Administrative Action
Preliminary Subdivision and Administrative Site Review

Case File / Name: S-41-15 / SR-14-14 / Bacarra II Subdivision and Apartments

SUBJECT: S-41-15, SR-14-14

OFFICIAL ACTION: **Approval with conditions**

S-41-15/SR-14-14 Preliminary Subdivision and Site Review Layout

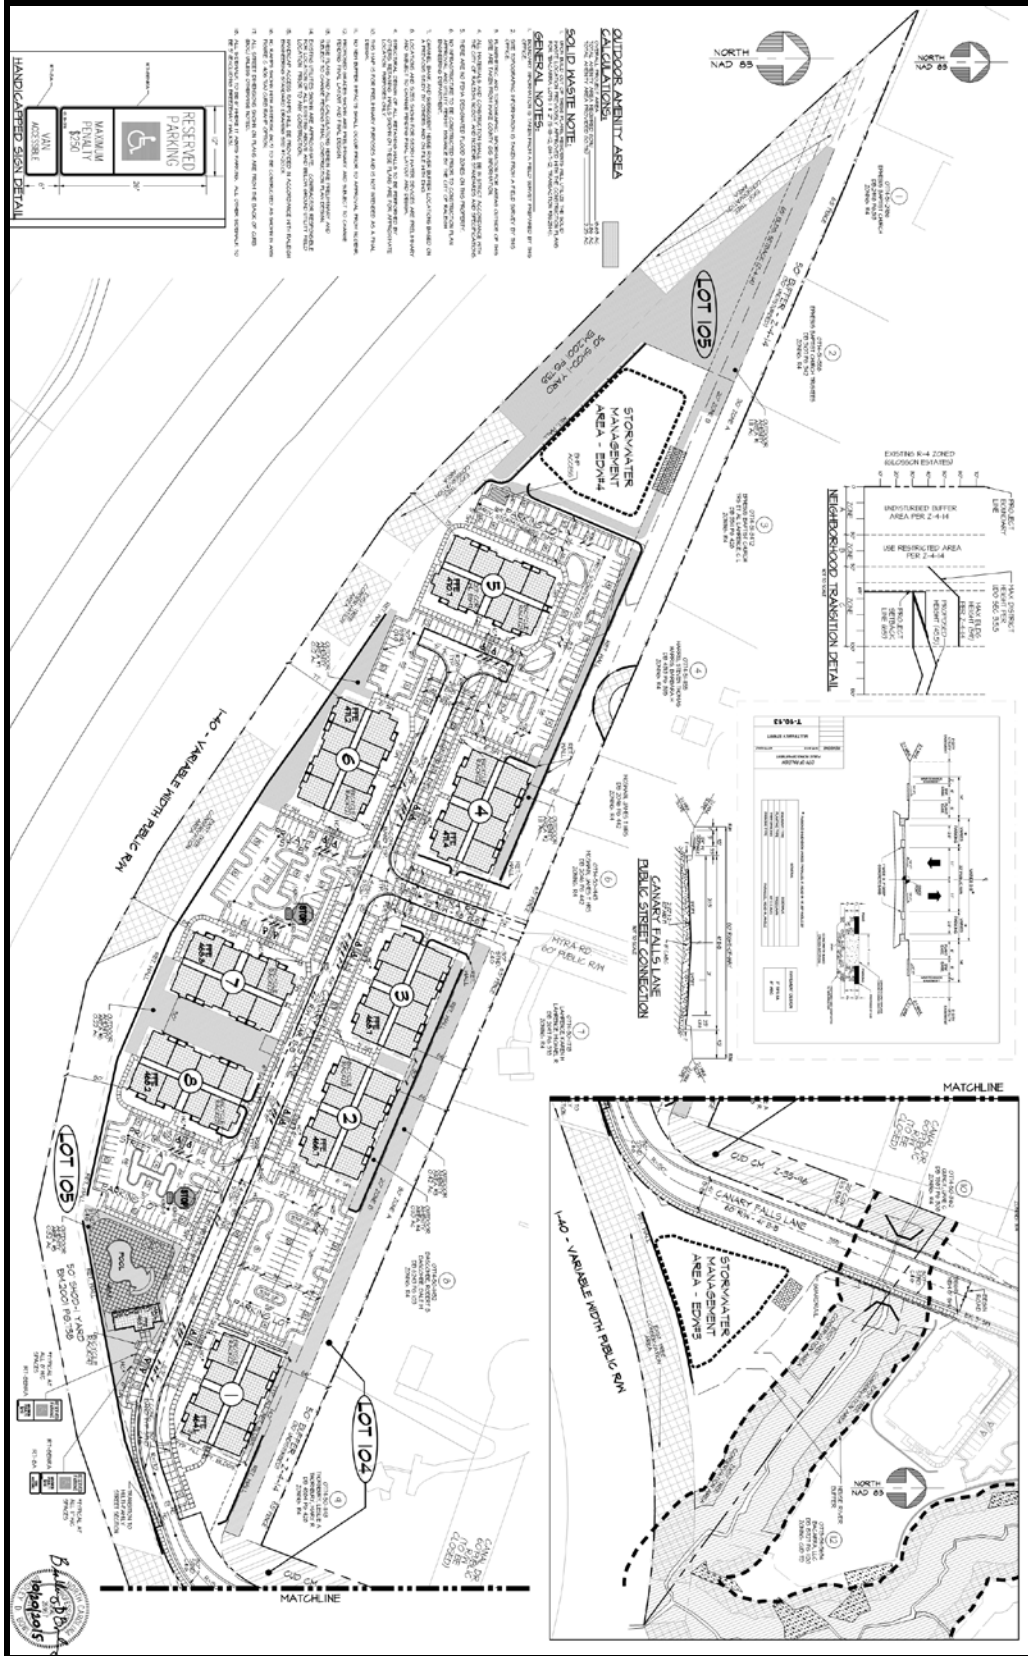
CONDITIONS OF APPROVAL:

- (1) That in accordance with Part 10A Section 9.4.4, a surety equal to of the cost of clearing, grubbing and reseeding a site, shall be paid to the City;

- (2) That as the developer proposes to disturb a designated riparian buffer, the North Carolina Division of Water Quality shall approve the disturbance of the riparian buffer before any grading or approval of construction drawings, (whichever first occurs) and evidence of such approval shall be provided to the Stormwater Engineer in the Public Works Department, and a written watercourse buffer permit is thereby issued by the Inspection Department before commencement of work;

- (3) That a final tree conservation plan with permit be approved by the Forestry Specialist. The plan must show metes and bounds descriptions of all tree conservation areas, and tree protection fence around all tree conservation areas. Tree protection fence must be located in the field and inspected by the Forestry Specialist;

- (4) That conditions 1-3, above, be met;
- (5) That a stormwater control plan with a stormwater operations and maintenance manual and budget shall be approved by the Stormwater Engineer in compliance with Part 10A Chapter 9 of the Unified Development

- (6) That a nitrogen offset payment must be made to a qualifying mitigation bank;
- (7) That all stormwater control measures and means of transporting stormwater runoff to and from any nitrogen and stormwater runoff control measures shall be shown on all plats for recording as private drainage easements and the plats shall contain the following note: "All private storm drainage easements & stormwater measures will be maintained by the property owners association;

- (13) That Infrastructure Construction Plans are approved by the City of Raleigh, including obtaining stub permits, tree impact permit and a street lighting plan;

- (14) That demolition permits for the existing structures be issued and this building permit number be shown on all maps for recording;
- (15) That in accordance with Part 10A Section 8.1.3, a surety equal to 125% of the cost of development related improvements, including streetscape trees on Canary Falls Lane and Myra Road street is paid to the Public Works Department;
